UNITED STATES
NUCLEAR REGULATORY COMMISSION
REGION V

CONFIRMATORY ACTION LETTER

Subject: Return of Palo Verde 1 to Power Operations from Current Outage

ANPP/NRC MEETING TO DISCUSS
PVNGS AUXILIARY SPRAY CAPABILITY AND
THE STARTUP TESTING EVENT OF SEPTEMBER 12, 1985

FIGURE 6.2.1-1

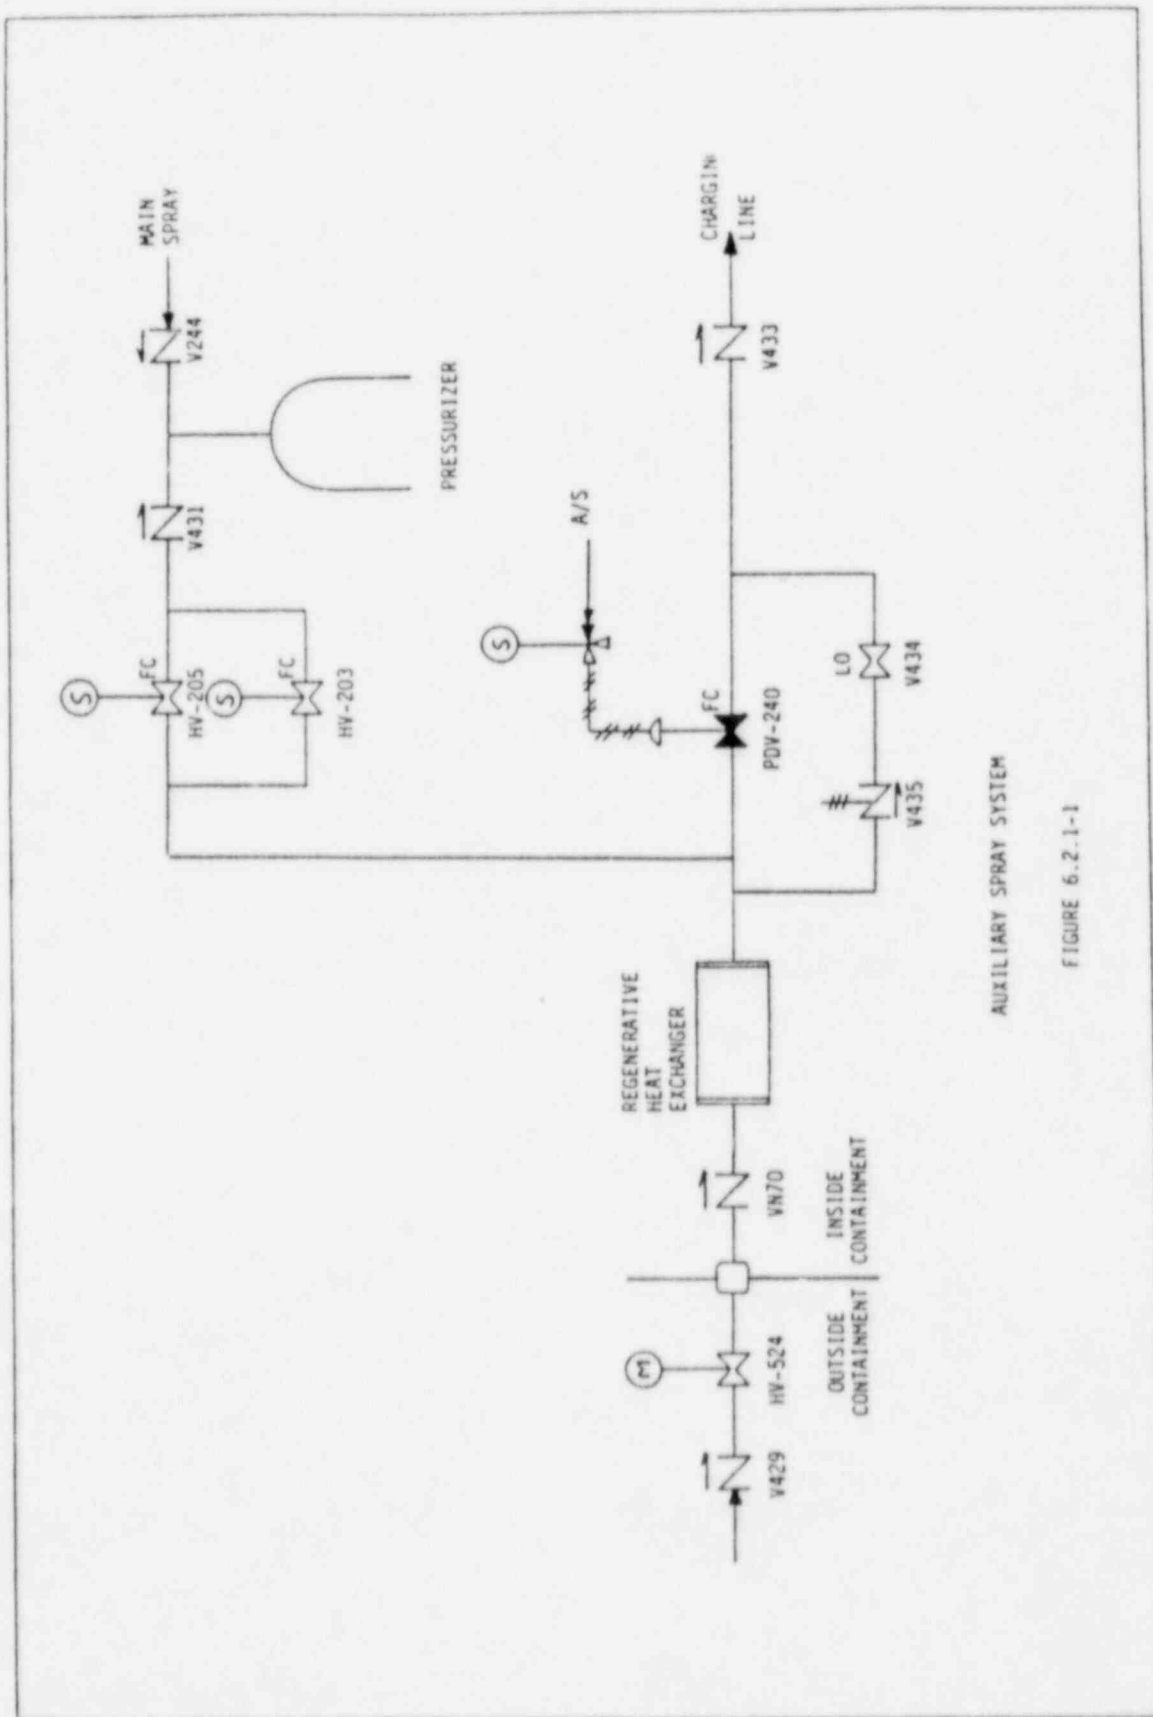
DETAILED DESCRIPTION IN RESPONSE TO 440.6

*why was some of water
not identified*
